**MINUTES
TOWN OF AMHERST
DESIGN ADVISORY BOARD MEETING
December 11, 2025
6:00 PM**

- 2.1. DESIGN REVIEW, SP-2025-09; LEGACY VILLAGE SENIOR HOUSING
Property Located at 3900-3904 Maple Road
Southern Tier Environments of Living, Inc., Petitioner

A proposed 4-story, 81-unit, 82,600 sq. ft. senior housing apartment building to be located on a new 2.25-acre parcel of land fronting on Meyer Road having and 117 parking spaces.

A 202

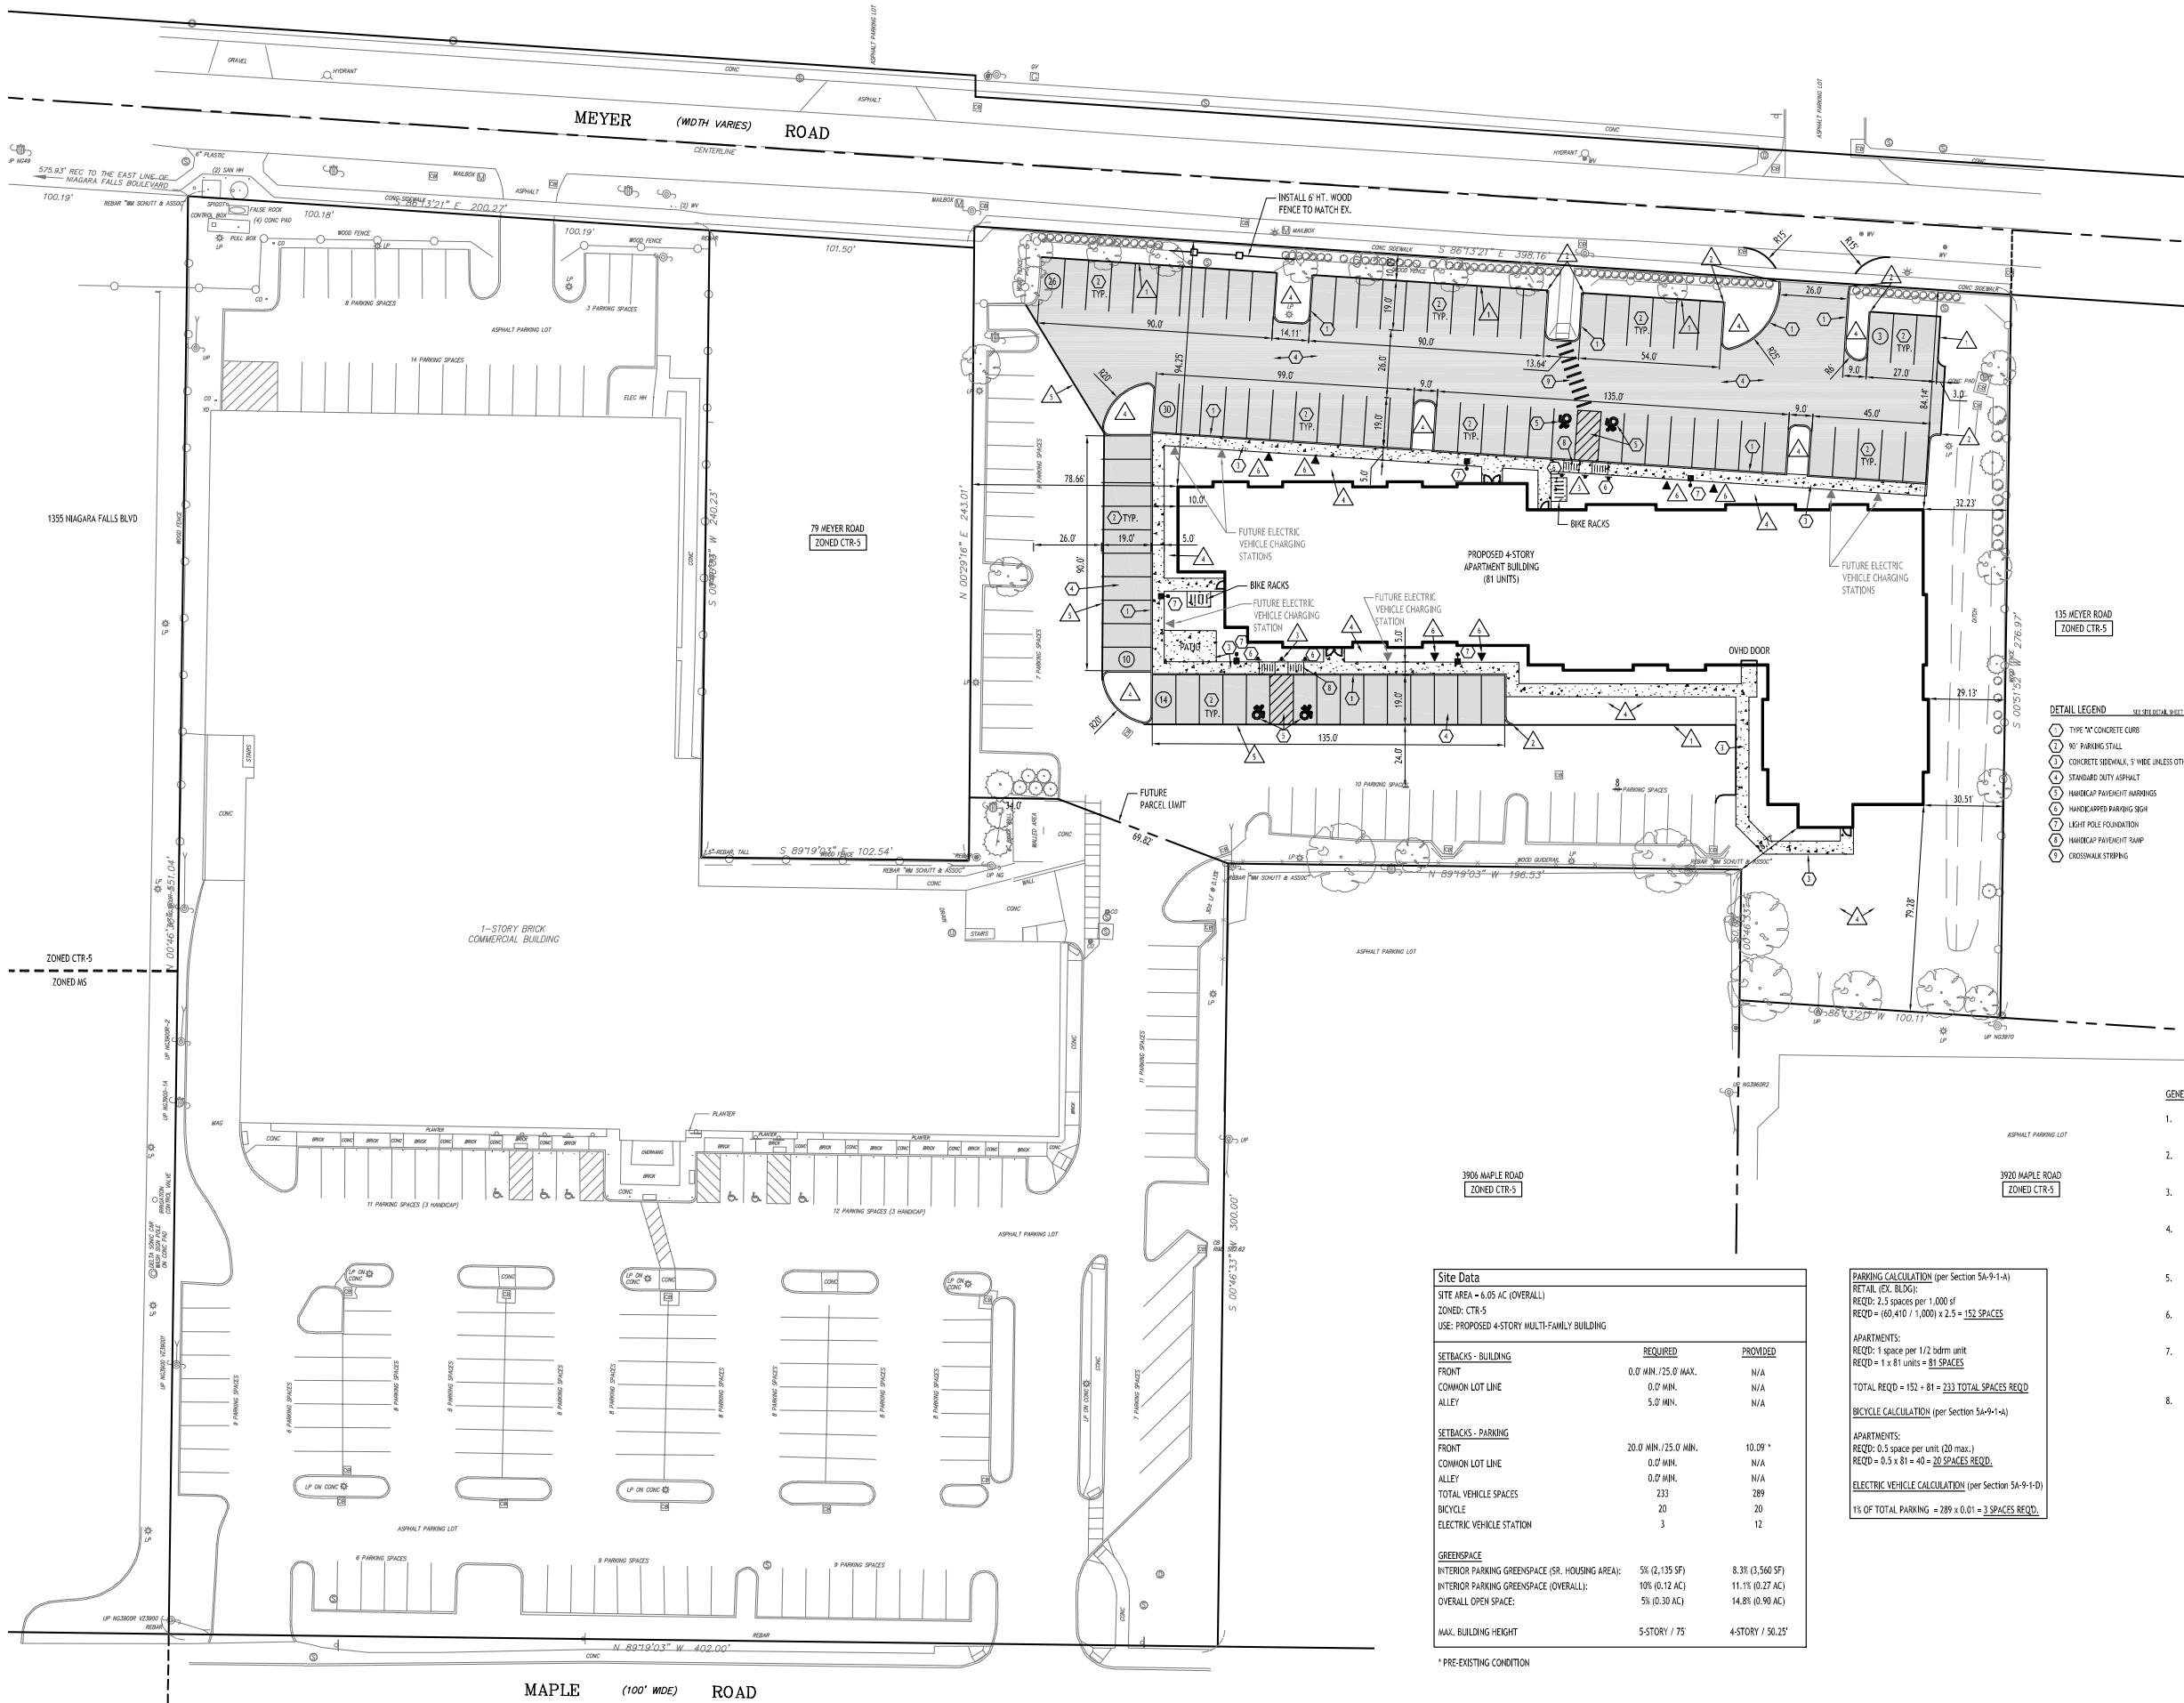
The Board suggested the petitioners consider varying the facades of the mass types to add more variety to the building and to accentuate the entryways.

The Board stated the main entryway was not accentuated, per the Design Guidelines, and provided several suggestions on how to approve its prominence. This included widening the main hallway to fit windows on either side of the door, changing the glass on the main doors,

altering the canopy (but keeping the shed style), and installing interesting lighting. The petitioners agreed to explore these options to highlight the main entrance.

The Board noted that the roof line feels flat despite the facade articulation due to the consistent cornices. They suggested the cornices be more varied which could also accentuate the main entryway.

- 6) That consideration be given to revise Sheet A-201 (Exterior Elevations) to show a varied cornice detail for the different facade mass types (Design Guidelines B-1a and B-4c).
- 7) That Sheet A-201 (Exterior Elevations) and the Colored Rendering be reconciled to present the same proposed canopies. It is recommended that the canopy over the main entrance be enhanced to differentiate the primary building entrance from windows of residential units (Design Guideline B-2b).
- 8) That Sheet A-201 (Exterior Elevations) and/or be revised to show proposed building lighting.

6. That consideration be given to revise Sheet A-201 (Exterior Elevations) to show a varied cornice detail for the different facade mass types (Design Guidelines B-1a and B-4c).
7. That Sheet A-201 (Exterior Elevations) and the Colored Rendering be reconciled to present the same proposed canopies. It is recommended that the canopy over the main entrance be enhanced to differentiate the primary building entrance from windows of residential units (Design Guideline B-2b).
8. That Sheet A-201 (Exterior Elevations) and/or be revised to show proposed building lighting.

C-100

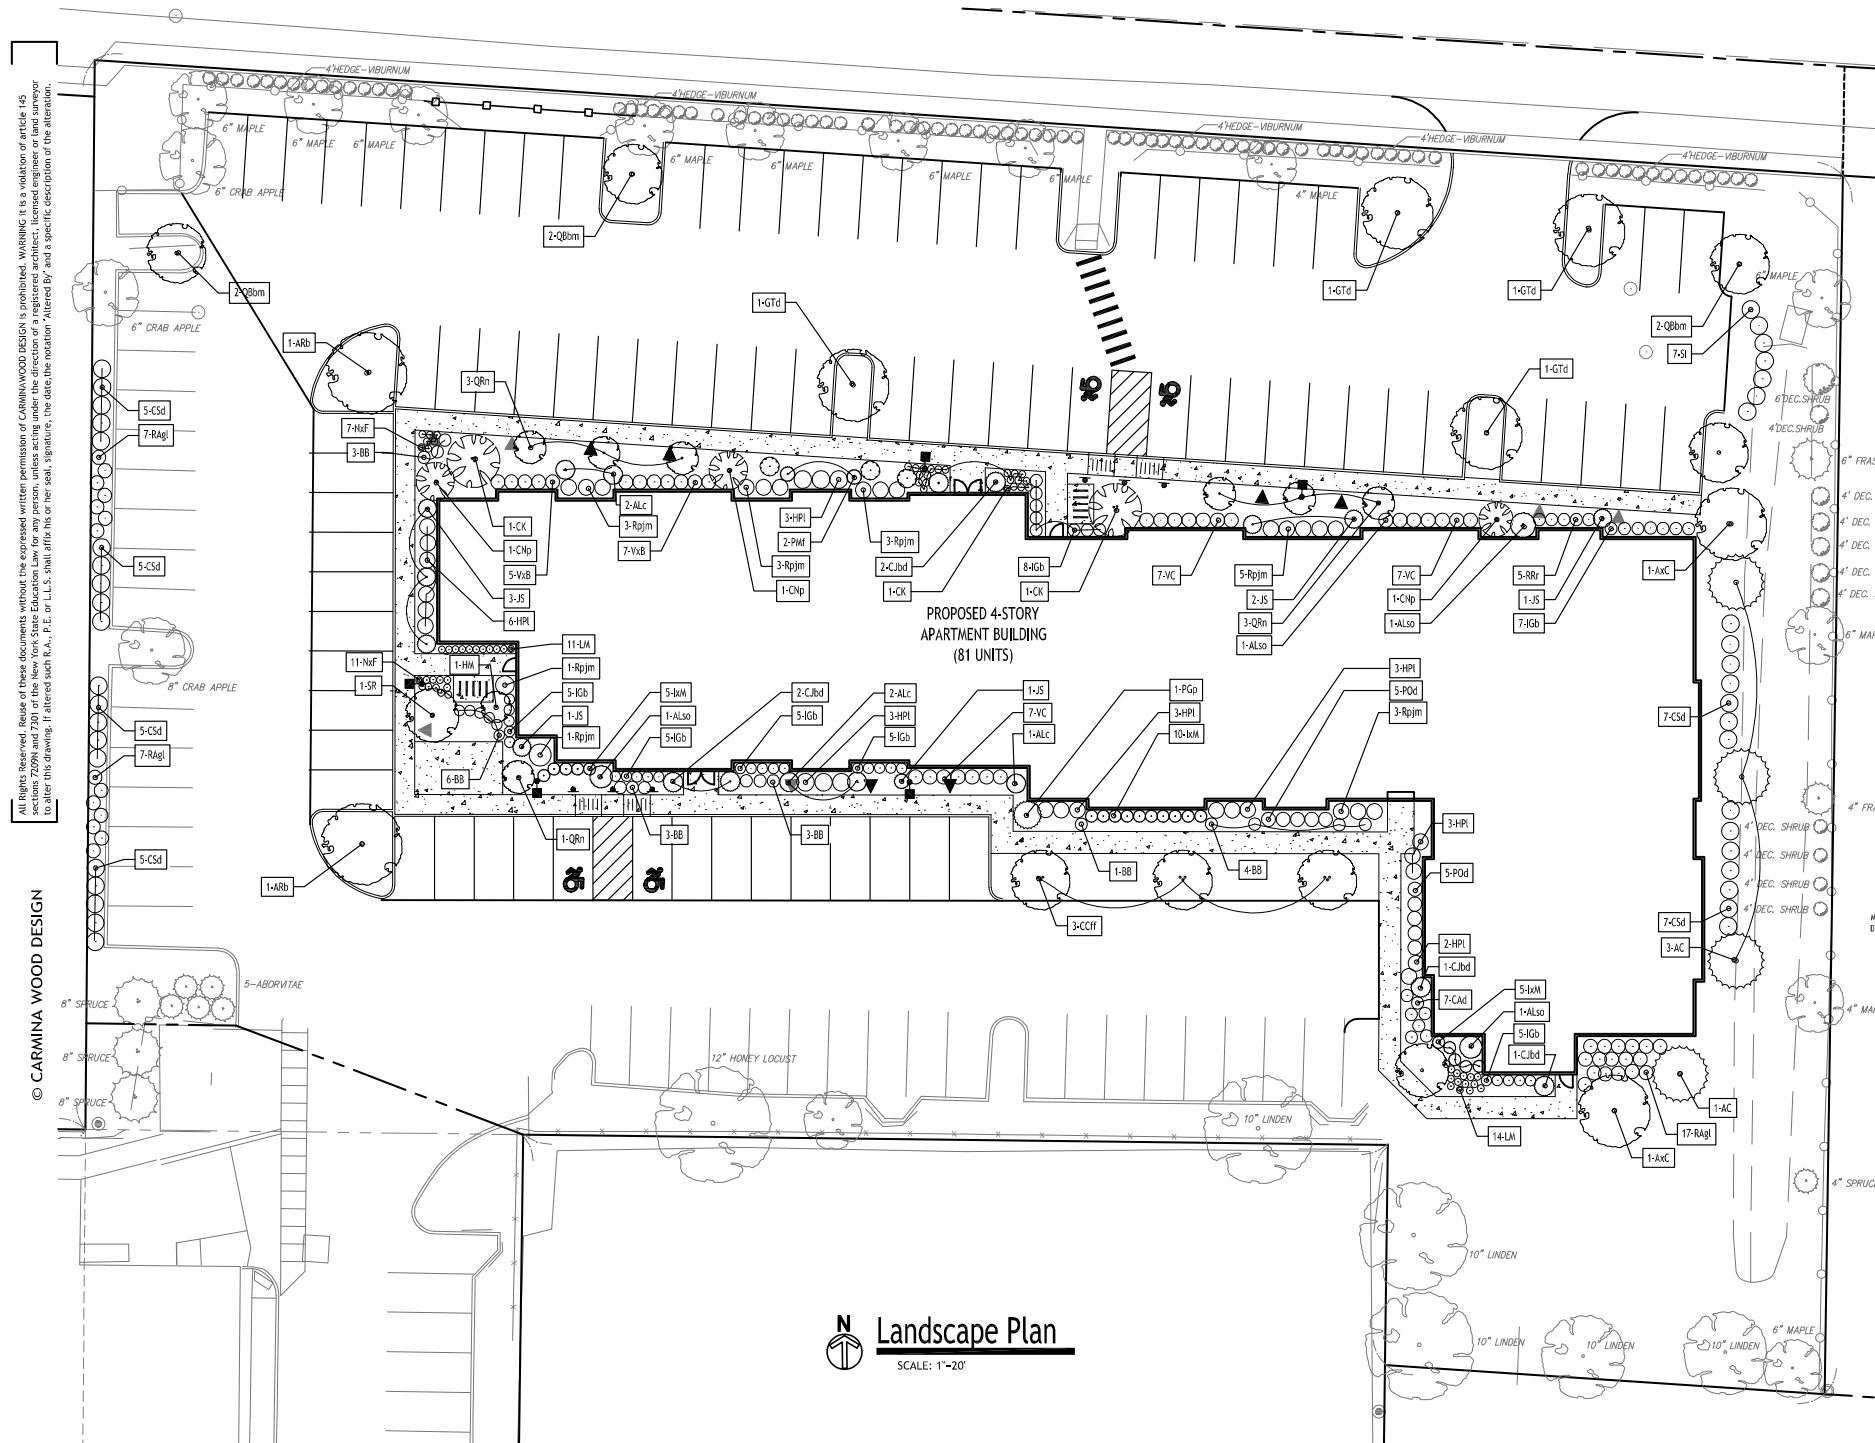
Mr. Talty inquired about a section of the pedestrian pathway as it was unclear if there was full connectivity to the adjoining commercial property. The petitioners confirmed the pathways will be connected by stripping.

The Board suggested the petitioners revisit the outdoor amenity space for both the tenants and the public. Ms. Colucci noted the patio space was small relative to the number of residential units and Mr. Talty encouraged them to add space for the public, possibly in the southeast corner. The petitioners agreed to review the outdoor spaces intended for the tenants and to place bench(es) along the sidewalk on Meyer Road for the public.

The Board stated the site required public art and suggested they place it in the tenant's green space, possibly in the southeast corner.

The Board recommended the plans show safe pedestrian access to the adjacent commercial plaza at 3904 Maple Road.

The Board recommended the plans be updated to reflect the removal of the fence and the addition of bench(es) close to the sidewalk.

- 1) That Sheet C-100 (Site Plan) be revised to show a safe pedestrian access from the proposed multi-family building to the southwest to the plaza at 3904 Maple Road (Design Guidelines A-1b and C-2c).

- 2) That Sheet C-100 (Site Plan) and Sheet L-101 (Landscape Plan) be revised to provide additional outdoor amenity space in the open area to the southeast of the building in order to make amenity spaces more proportional to the overall building/site (Design Guidelines A-2a and C-1d).

- 3) That Sheet C-100 (Site Plan) and Sheet L-101 (Landscape Plan) be revised to remove the existing and proposed fencing along Meyer Road and provide a seating area/bench in the landscaped area between the Meyer Road right of way and parking lot (Design Guidelines A-2b and C-3b).

- 4) That Sheet C-100 (Site Plan) and Sheet L-101 (Landscape Plan) be revised to provide the proposed location in the southeast corner of the property and details of a public art amenity (Design Guideline A-4a).

1. That Sheet C-100 (Site Plan) be revised to show a safe pedestrian access from the proposed multi-family building to the southwest to the plaza at 3904 Maple Road (Design Guidelines A-1b and C-2c).

2. That Sheet C-100 (Site Plan) and Sheet L-101 (Landscape Plan) be revised to provide additional outdoor amenity space in the open area to the southeast of the building in order to make amenity spaces more proportional to the overall building/site (Design Guidelines A-2a and C-1d).

3. That Sheet C-100 (Site Plan) and Sheet L-101 (Landscape Plan) be revised to remove the existing and proposed fencing along Meyer Road and provide a seating area/bench in the landscaped area between the Meyer Road right of way and parking lot (Design Guidelines A-2b and C-3b).

4. That Sheet C-100 (Site Plan) and Sheet L-101 (Landscape Plan) be revised to provide the proposed location in the southeast corner of the property and details of a public art amenity (Design Guideline A-4a).
